PLAN COMMISSION PC #22-019
Patton School Expansion
1616 North Patton Avenue
Round 2

Patton School Building Expansion
1616 N Patton Ave

Round 2 Review Comments

Case Number: PC 22-019

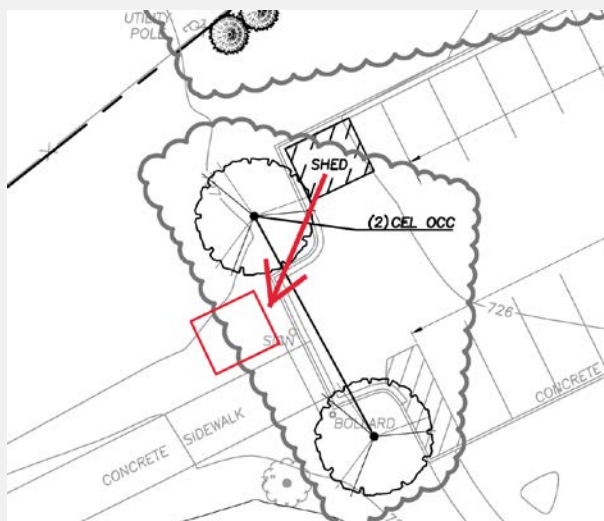
29. The response to comment #14 is insufficient. The location of the shed has not changed. Please move the shed from the parking stalls and relocate so as to add two additional parking stalls to the existing parking lot. The North lot is often at capacity and additional parking stalls would be beneficial in this location. Please justify why the shed cannot be moved as shown below:
